UNITED STATES
NUCLEAR REGULATORY COMMISSION
WASHINGTON, D. C. 20555

CALVERT CLIFFS NUCLEAR POWER PLANT, UNIT 2

AMENDMENT TO FACILITY OPERATING LICENSE

Amendment No. 131
License No. DPR-69

FIGURE 3.11-2b
 CALVERT CLIFFS UNIT 2 HEATUP CURVE, 12 EPFY
 REACTOR COOLANT SYSTEM PRESSURE TEMPERATURE LIMITS

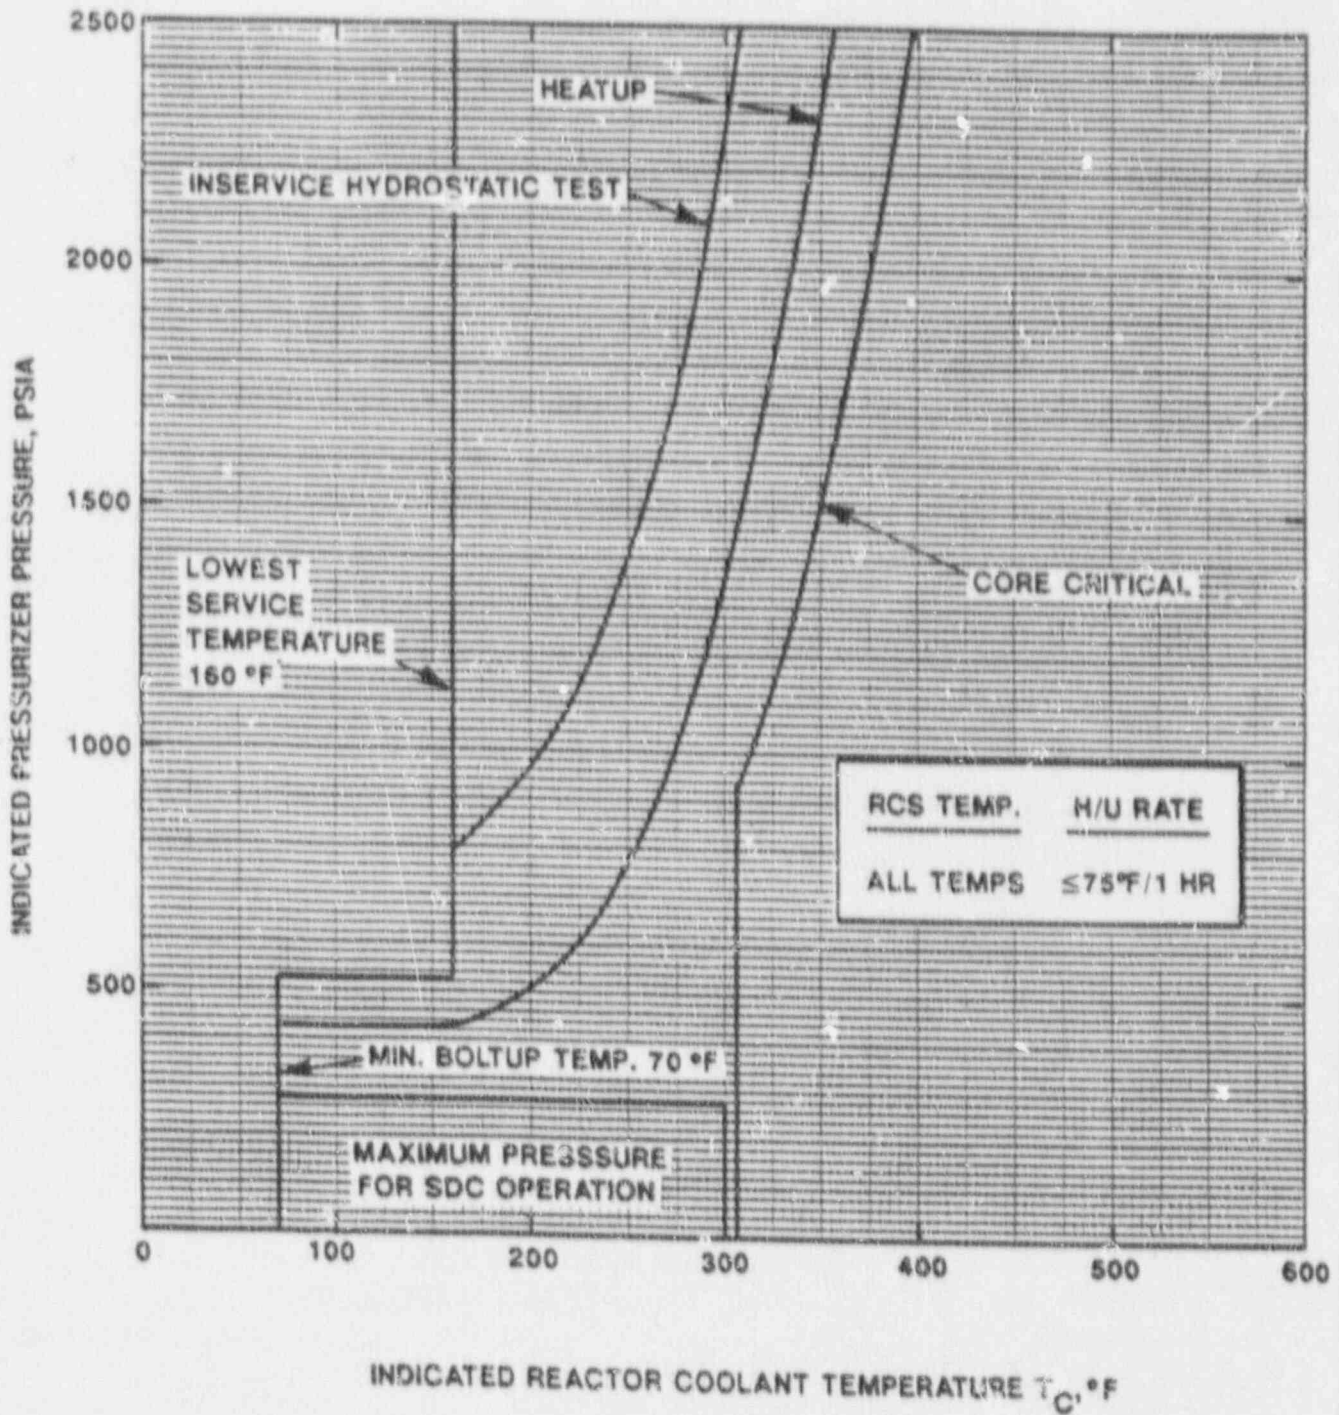
3.4.9.1 The Reactor Coolant System (except the pressurizer) temperature and pressure shall be limited in accordance with the limit lines shown on Figure 3.4-2 during heatup, cooldown, criticality, and inservice leak and hydrostatic testing with:

Similarly, 10 CFR Part 50 specifies that core critical limits be established based on material considerations. This limit is shown on the heatup curve, Figure 3.4-2b. Note that this limit does not consider the core reactivity safety analyses that actually control the temperature at which the core can be brought critical.

FIGURE 3.4-2c
 CALVERT CLIFFS UNIT 2 COOLDOWN CURVE, 12 EPFY
 REACTOR COOLANT SYSTEM PRESSURE TEMPERATURE LIMITS

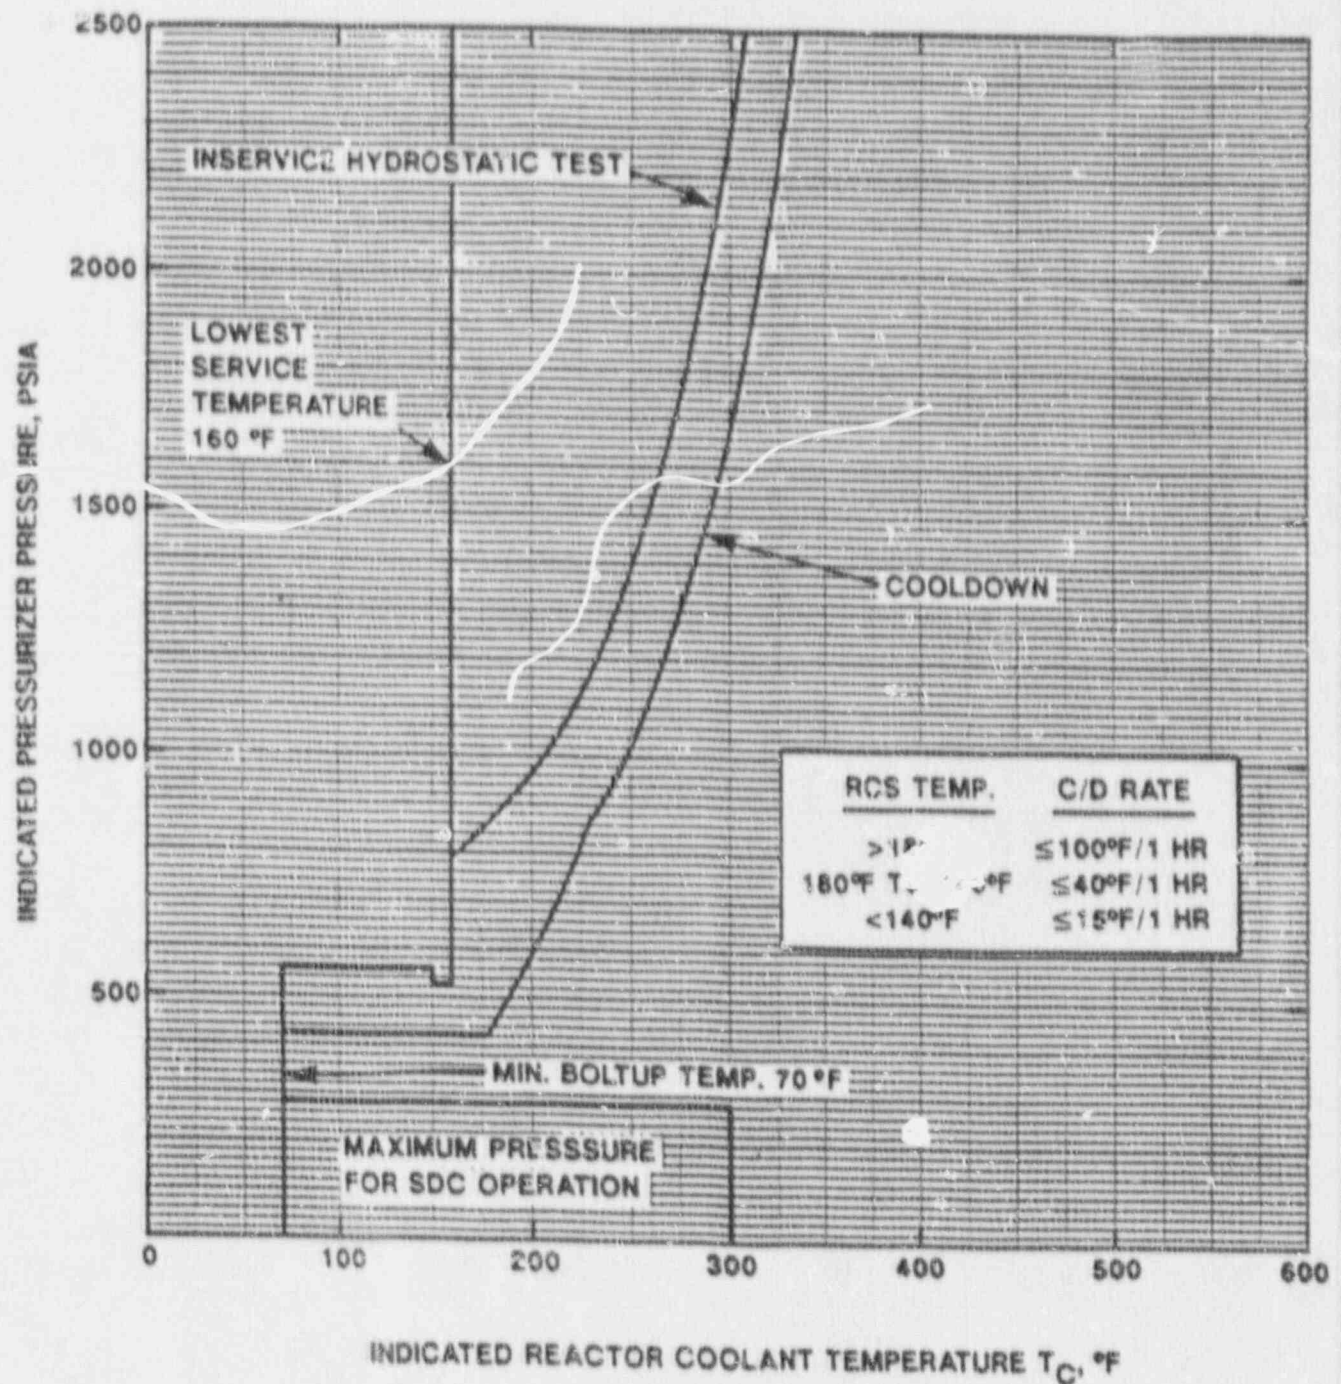
- 2. Verify the excessive flow condition did not raise pressure above the maximum allowable pressure for the given RCS temperature on Figure 3.4-2b or Figure 3.4-2c.

The horizontal line between the minimum boltup temperature and the Lowest Service Temperature is defined by the ASME Boiler and Pressure Vessel Code as 20% of the pre-operational hydrostatic test pressure. The change in the line at 150°F on the cooldown curve is due to a cessation of RCP flow induced pressure deviation, since no RCPs are permitted to operate during a cooldown below 150°F.
